## THE NORTH EDGE 1405 NORTH FEDERAL HIGHWAY APPLICABLE CODES DELRAY BEACH PALM BEACH COUNTY, FL OCCUPANCY CLASSIFICATION

REVISED 12/01/22  
AS PER DEVELOPMENT SERVICES  
COMMENTS:  
1. UPDATED RENDERING AND  
ADDED RENDERING NOTE.

THIS DRAWING IS NOT FOR CONSTRUCTION,  
IT HAS BEEN ISSUED FOR GOVERNMENTAL  
REVIEW AND/OR PRELIMINARY PRICING.

**PROPOSED EXTERIOR ELEVATIONS**

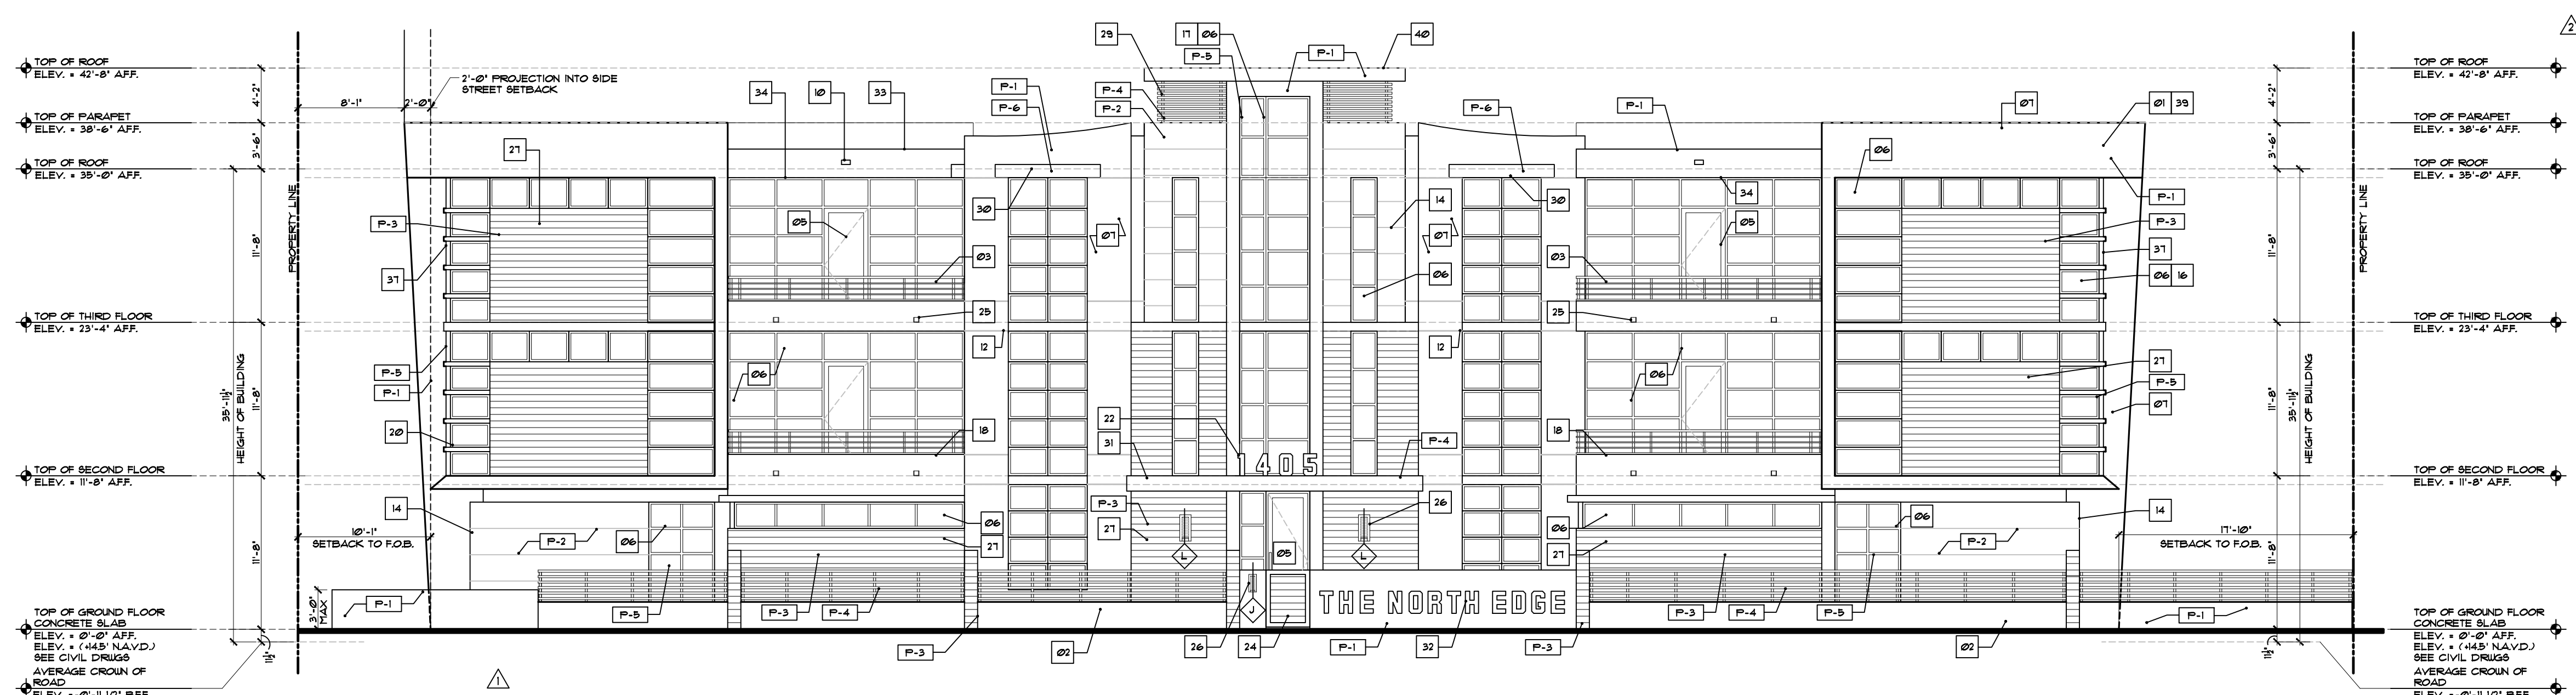
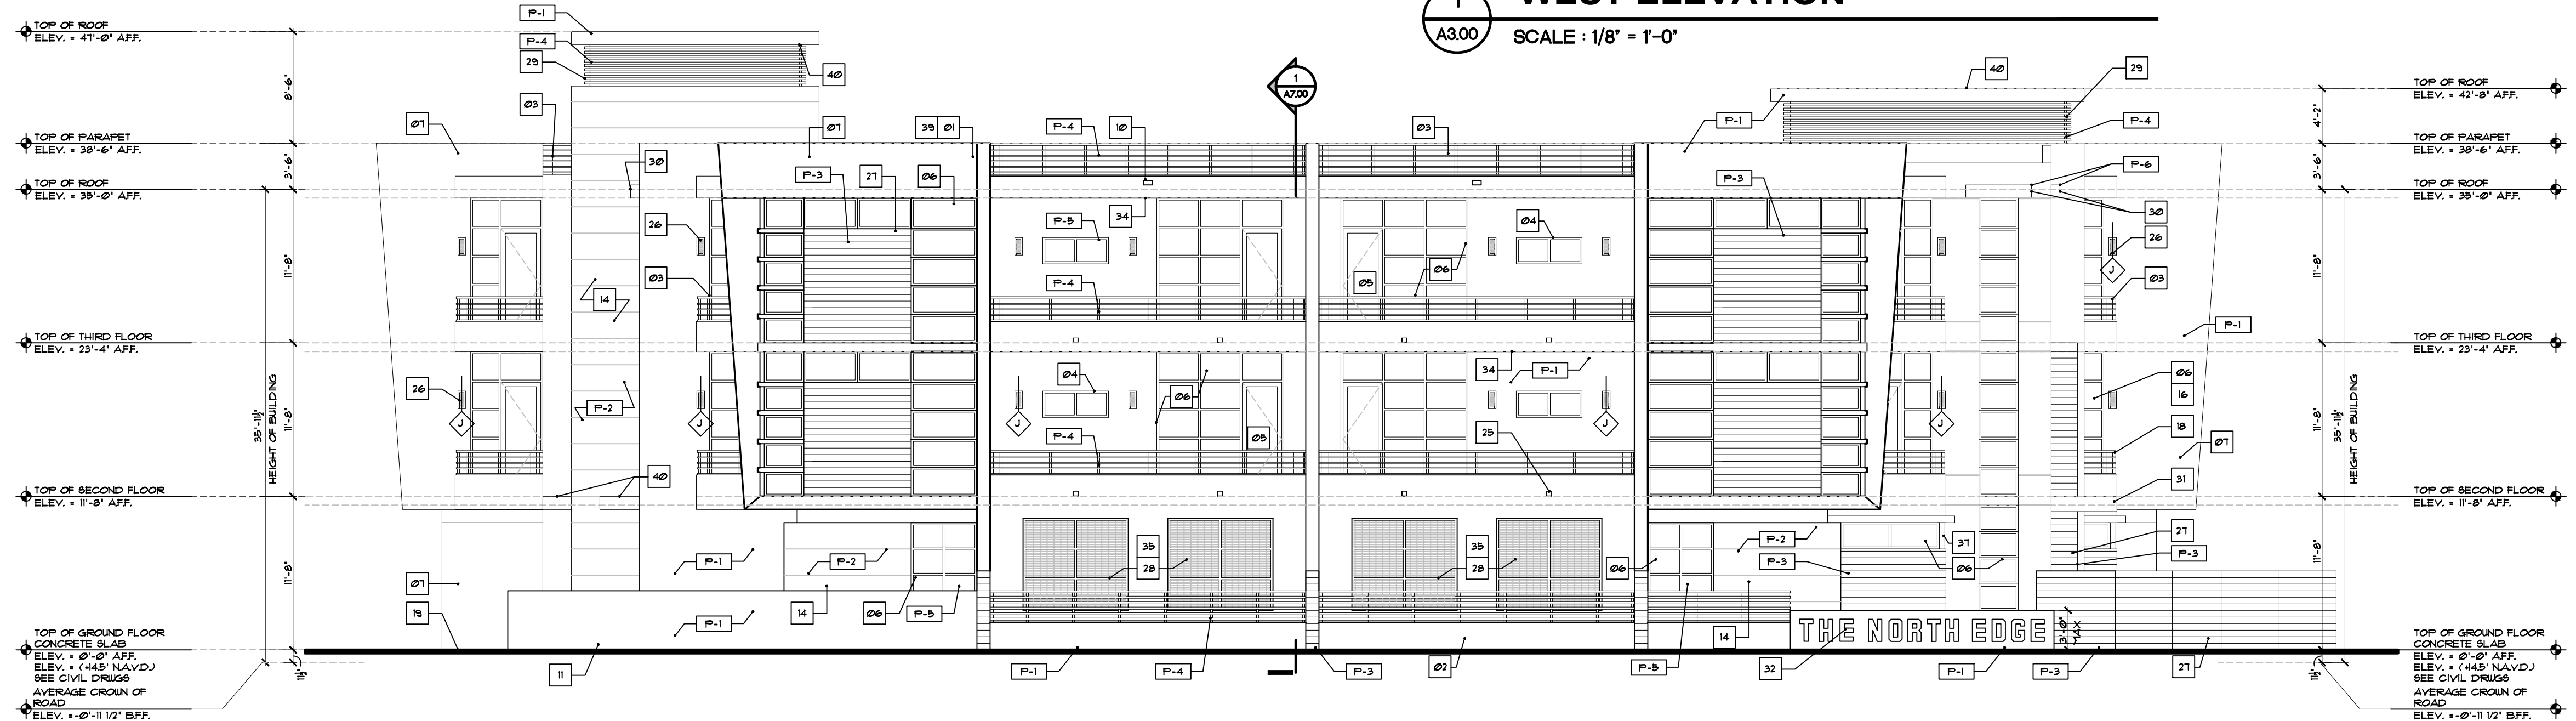
REVISD 12/22	AS PER DEVELOPMENT SERVICES COMMENTS:
1	ADDED AVERAGE CROWN OF ROAD
2	ADDED WINDOWS ALONG THE WEST AND NORTH ELEVATION AT THE GARAGE
3	ADDED WINDOWS AND WOOD SIDING AT THE ENTRY TOWER
4	UPDATED THE SCREEN PATTERN AT GARAGE OPENINGS
5	ADJUSTED NORTH ELEVATION AT THE STAIR TOWER
REVISD 12/22	AS PER DEVELOPMENT SERVICES COMMENTS:
1	UPDATED LIGHT FIXTURES

DRAWING TITLE: **PROPOSED EXTERIOR ELEVATIONS**

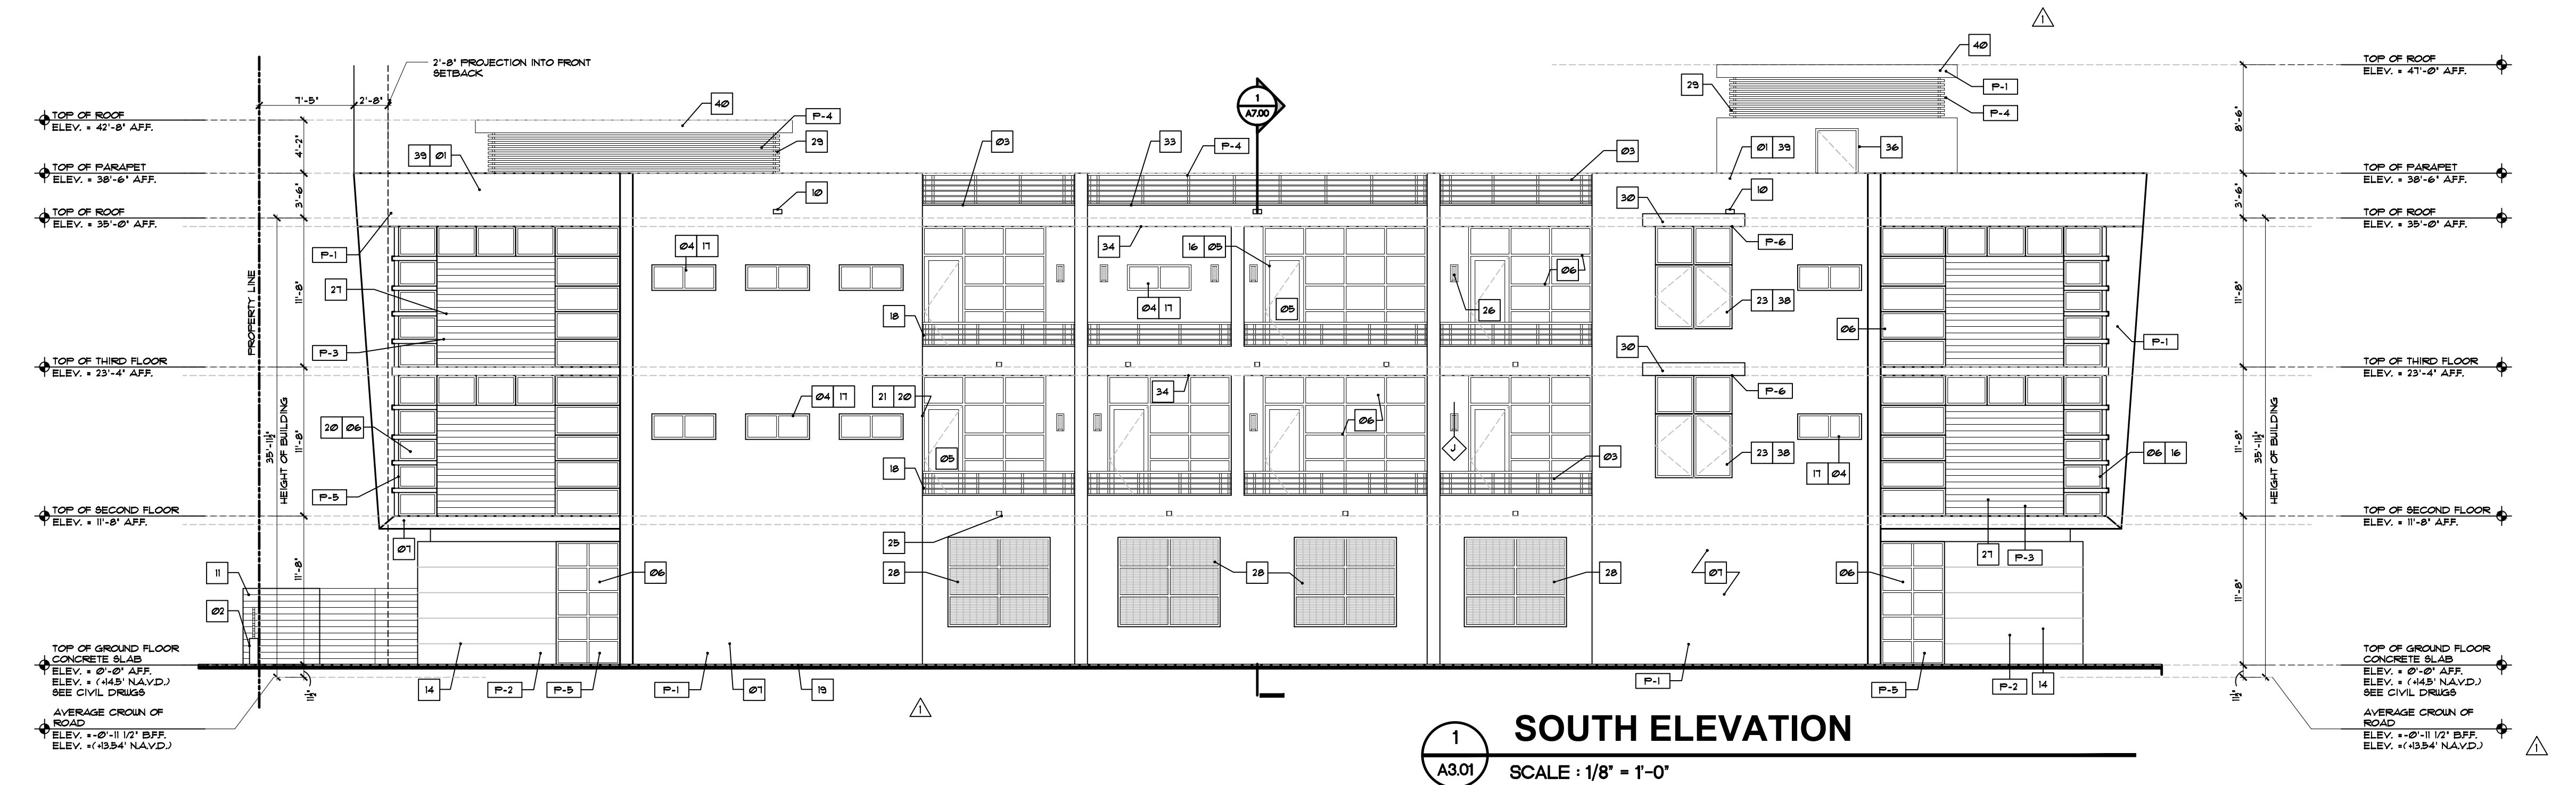
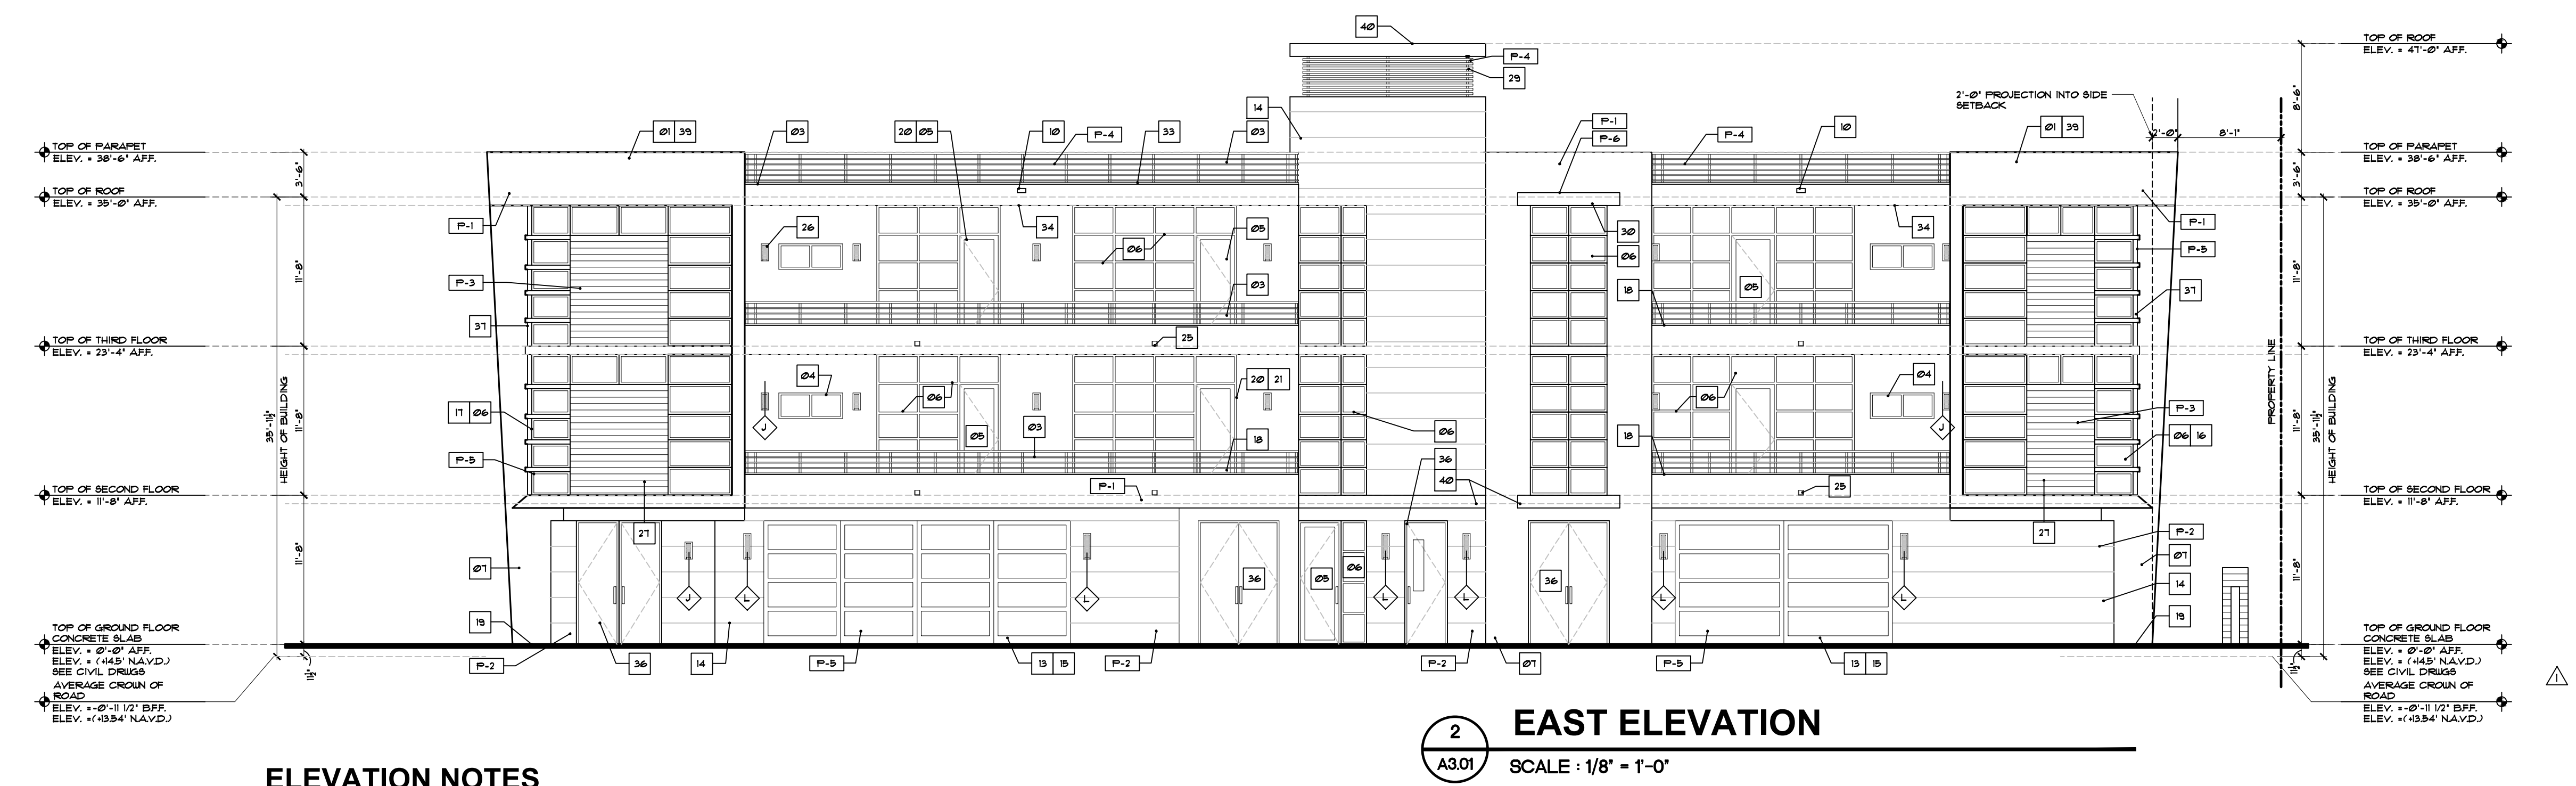
- REVISD 12/21/22
- AS PER DEVELOPMENT SERVICES COMMENTS:
- 1. ADDED AVERAGE CROWN OF ROAD
- 2. ADDED WINDOWS ALONG THE SOUTH ELEVATION AT THE GARAGE
- 3. UPDATED THE SCREEN PATTERN AT GARAGE OPENINGS
- 4. ADJUSTED EAST/SOUTH ELEVATION AT THE STAIR TOWER
- 5. CHANGED GARAGE DOOR TO BE 11'-0"
